Product Change Notification: PCN-24-229857

Product Description: (Text limited to 120 characters)
Ampseal Plug Assembly Product Drawing Clarification

General Description of Changes
The Industrial and Commercial Transportation business unit of TE Connectivity is making a minor drawing change to clarify the verbiage of the note that calls out the material of the housings for the Ampseal Plug Assembly for the product drawing(s) listed below.
Other attachments:
[2293782_Redline](#)
[2371886_Redline](#)

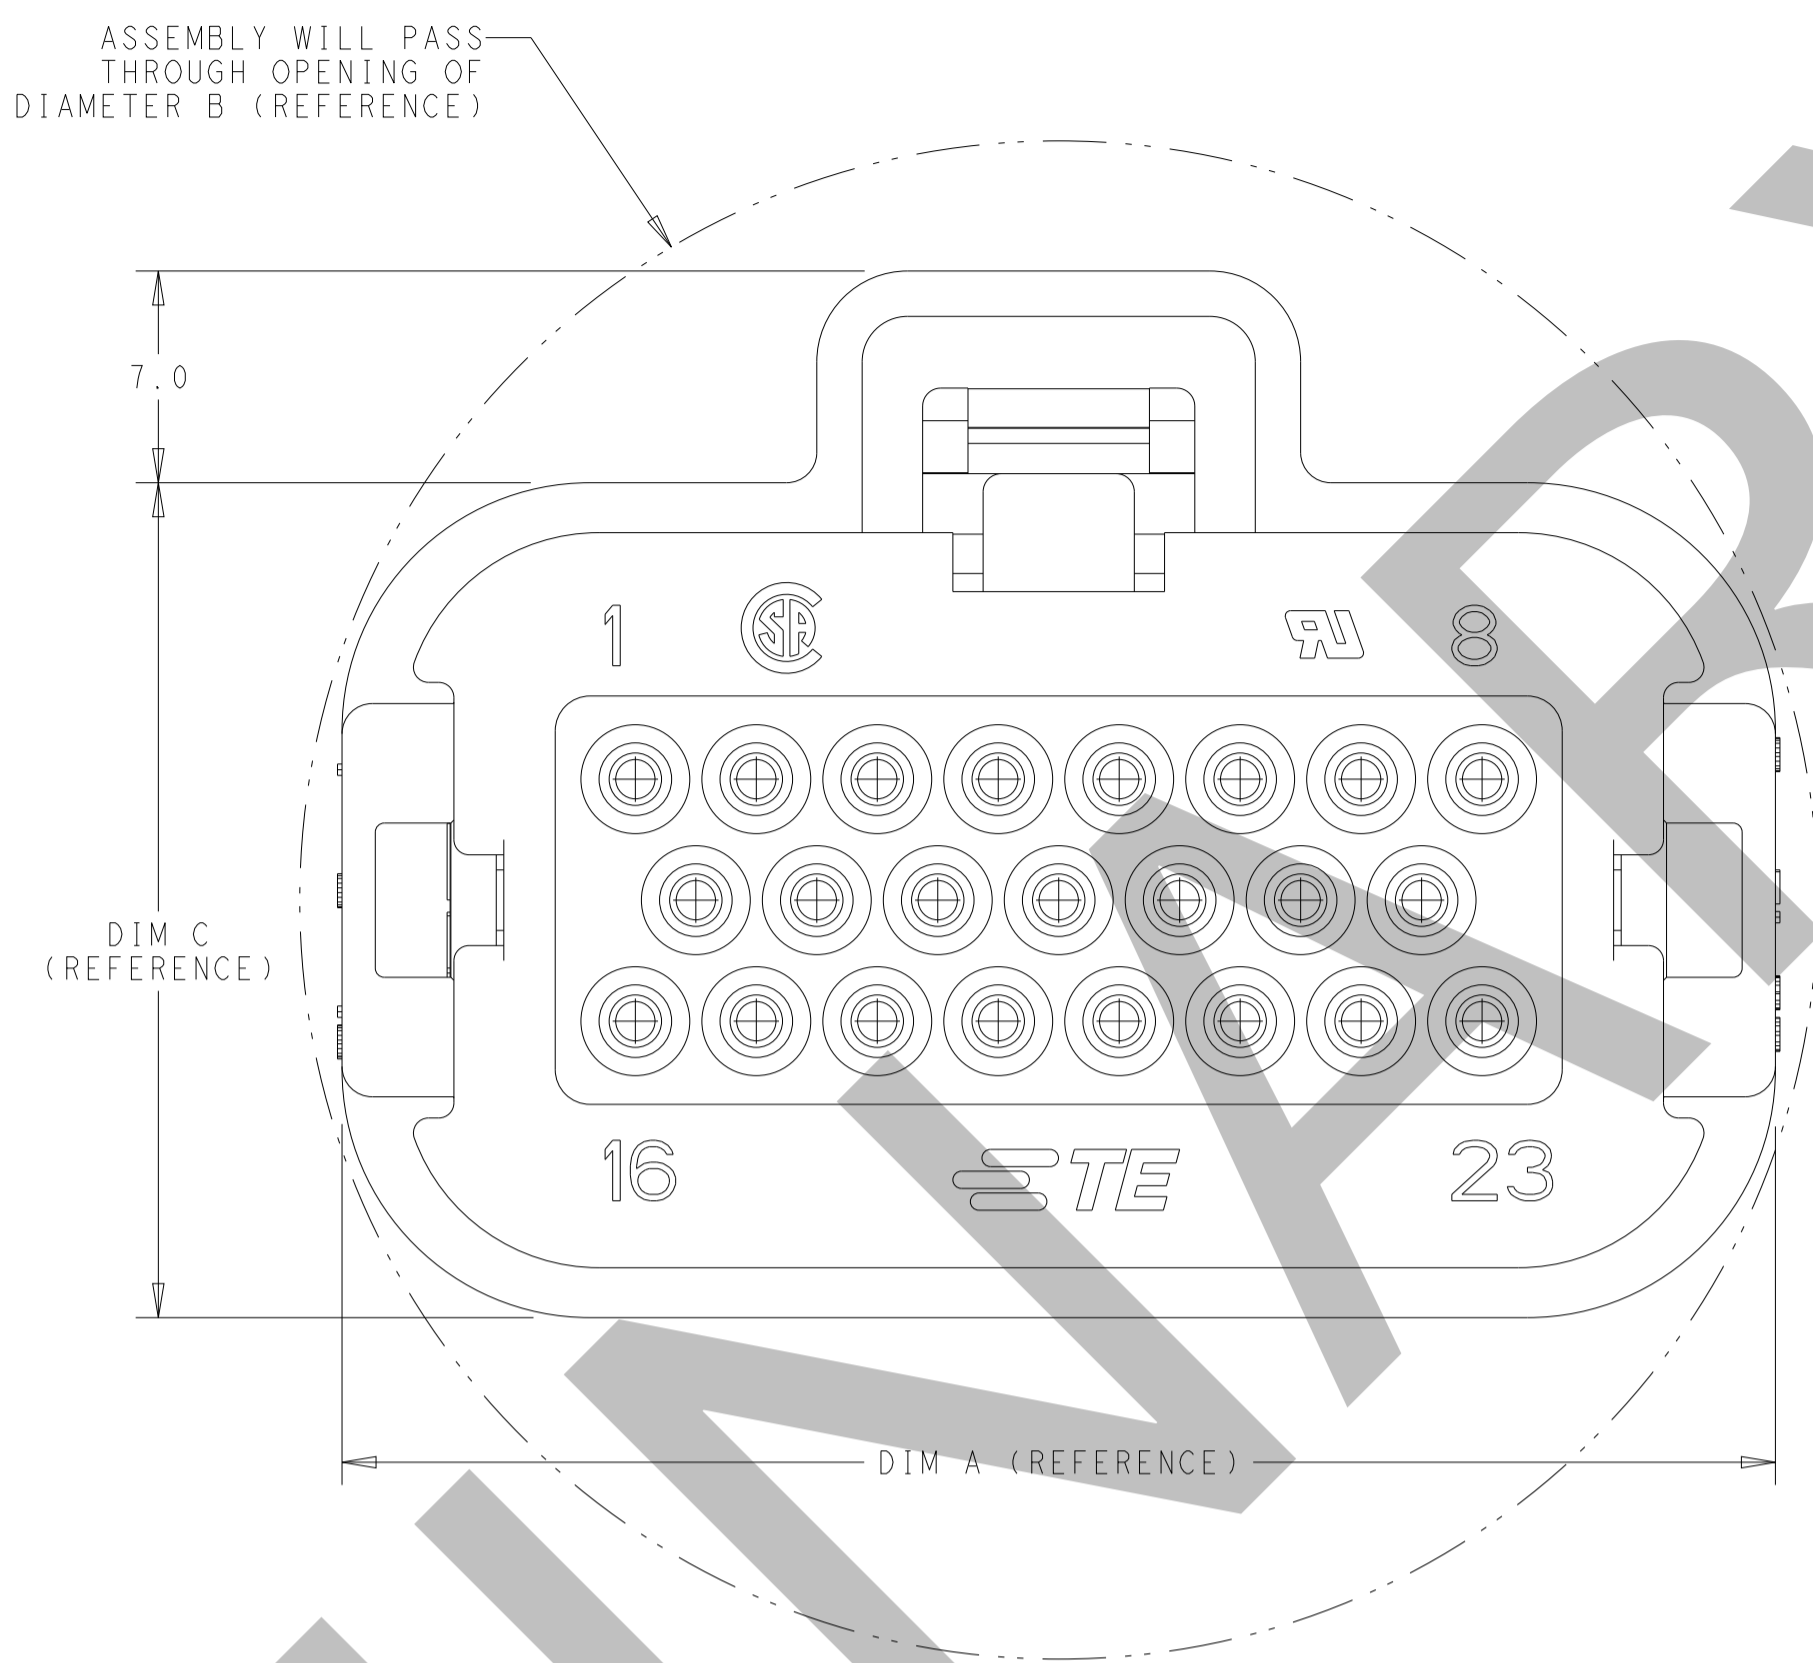
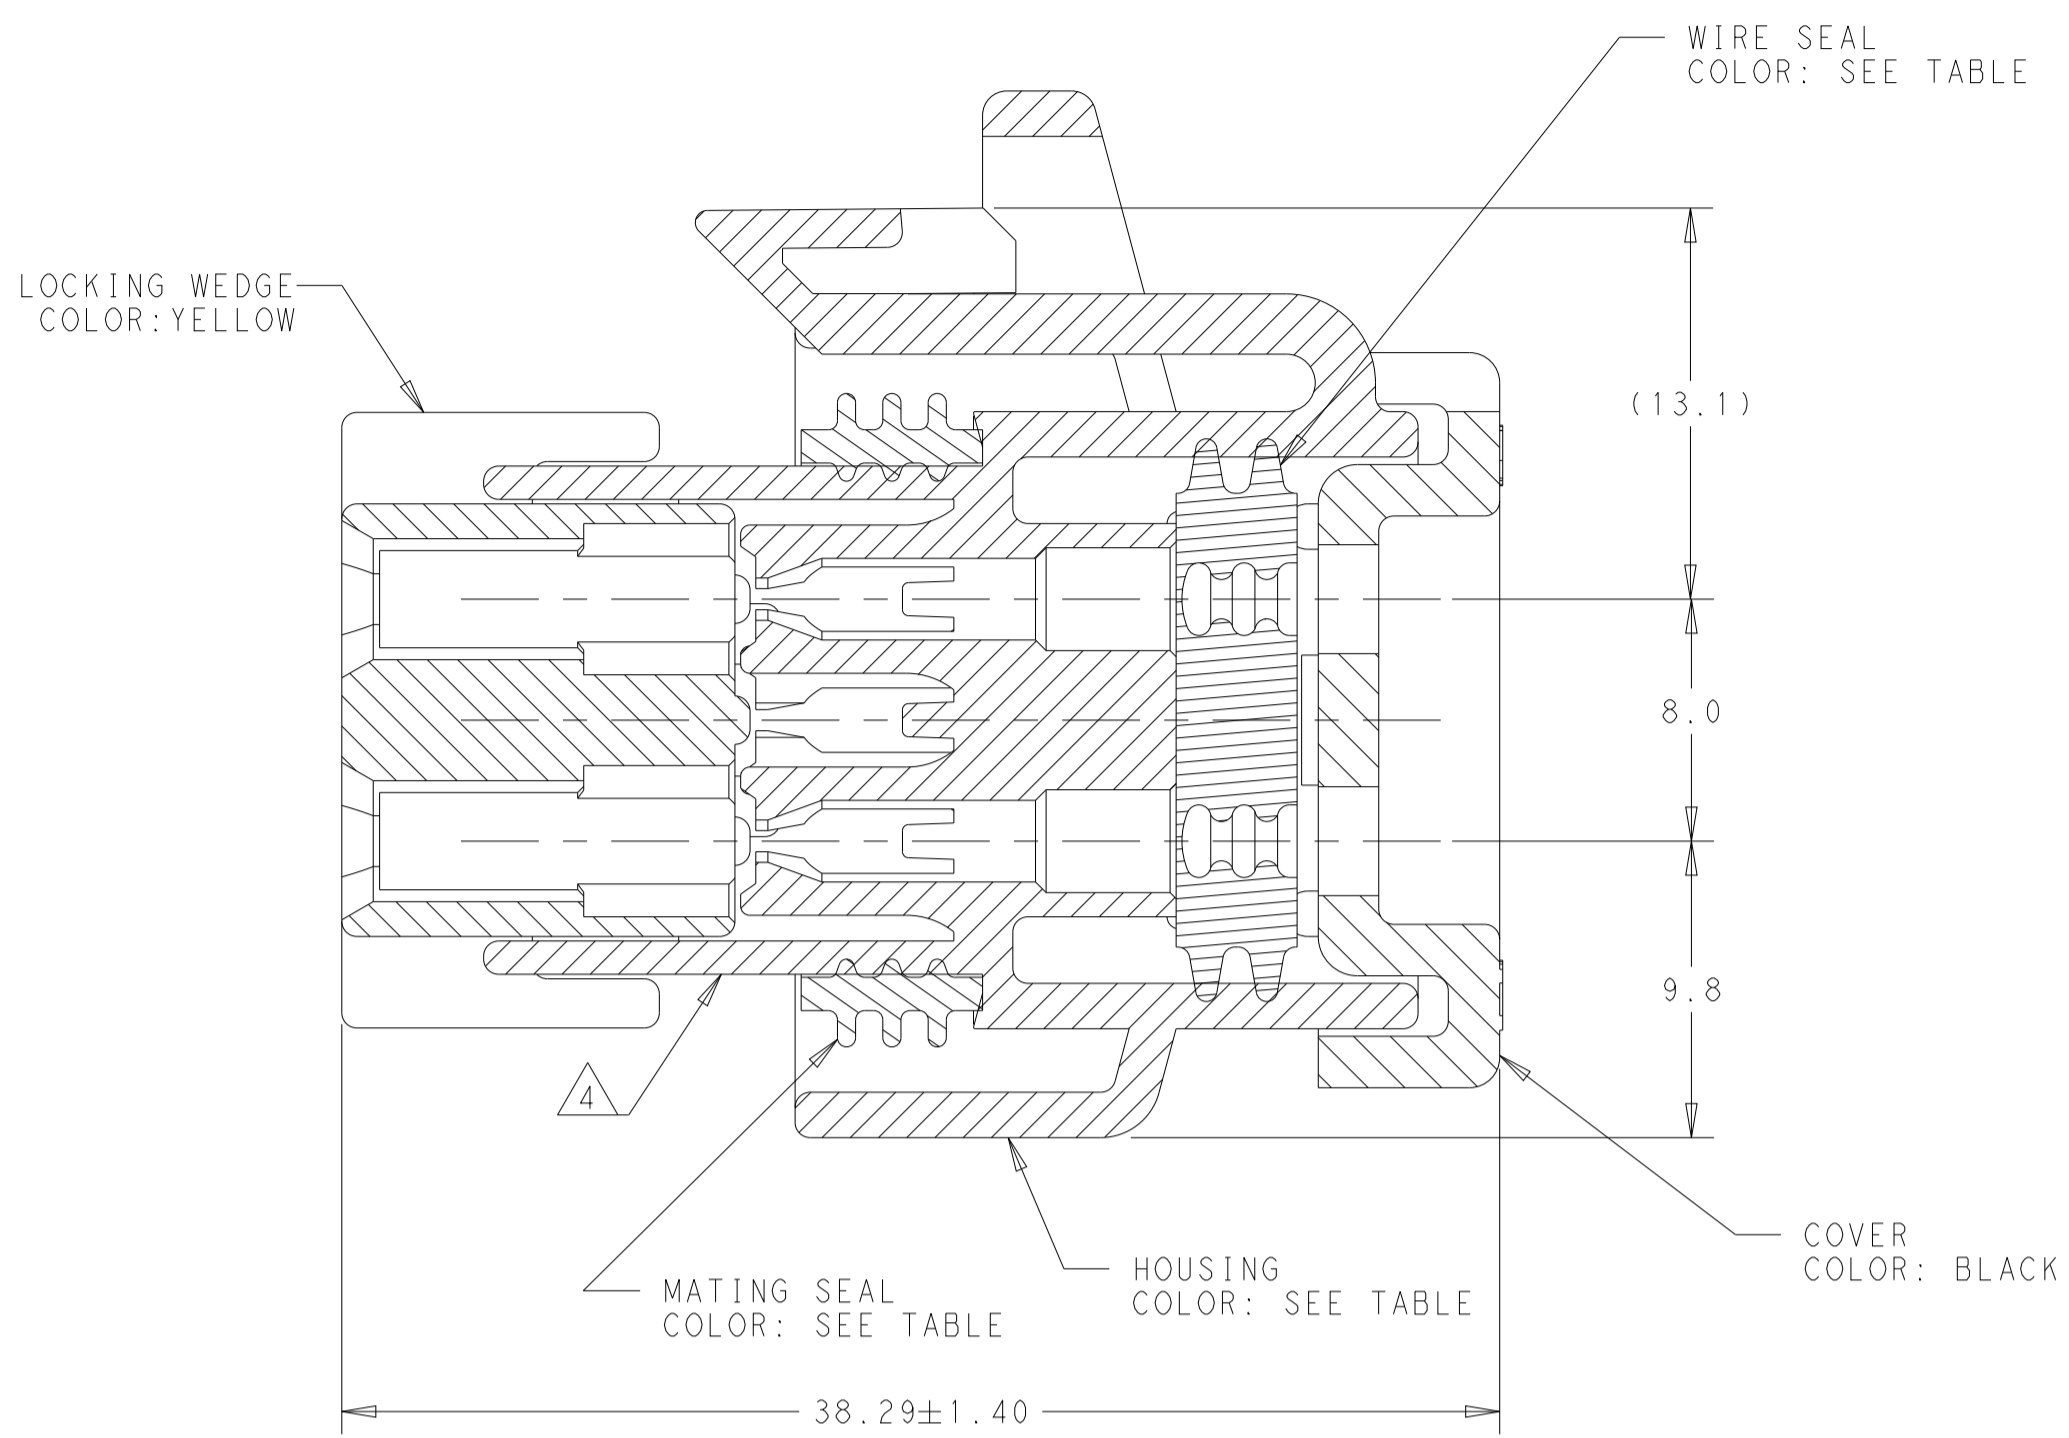
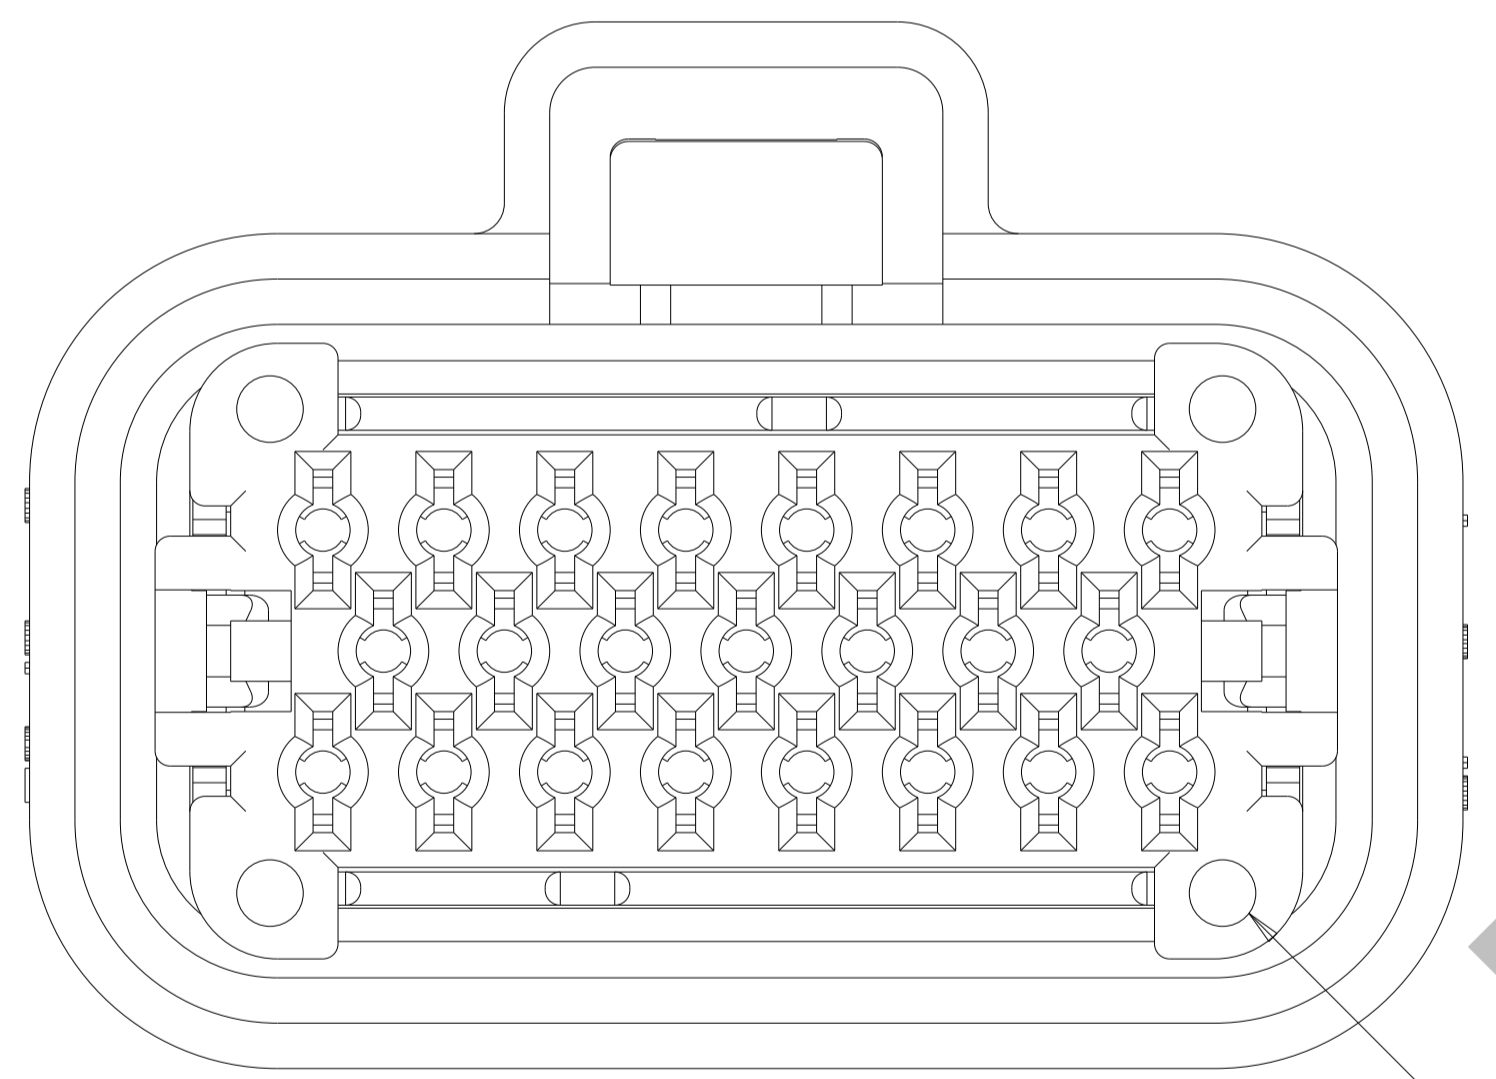
- MATERIAL: HOUSING - UL94V-0 PBT+PC
 LOCKING WEDGE - UL94V-0 PBT, YELLOW
 COVER - UL94V-0 PBT, BLACK
 MATING SEAL - SILICONE
 WIRE SEAL - SILICONE
- HOUSING COLORS ARE MECHANICALLY KEYPED TO MATE WITH IDENTICALLY COLORED HEADER ASSEMBLIES
- PLUG USES REELED TERMINAL 770520 OR LOOSE PIECE TERMINAL 770854
 770520-5, TIN PLATE, 20-22AWG TXL WIRE
 770520-6, TIN PLATE, 22-24AWG TXL WIRE
 770520-8, GOLD PLATE, 20-22AWG TXL WIRE
 1-770520-1, GOLD PLATE, 22-24AWG TXL WIRE
- DATE CODE ON THIS SURFACE. USES 5 DIGIT CODE:
 FIRST 2 DIGITS = YEAR, SECOND 2 DIGITS = WEEK,
 LAST DIGIT = DAY
- OPTIONAL VOID CORING ON 35 POSITION PLUG ASSEMBLY 2371885
- PRODUCT IS DESIGNED FOR WIRE OD OF 1.4 - 1.8mm
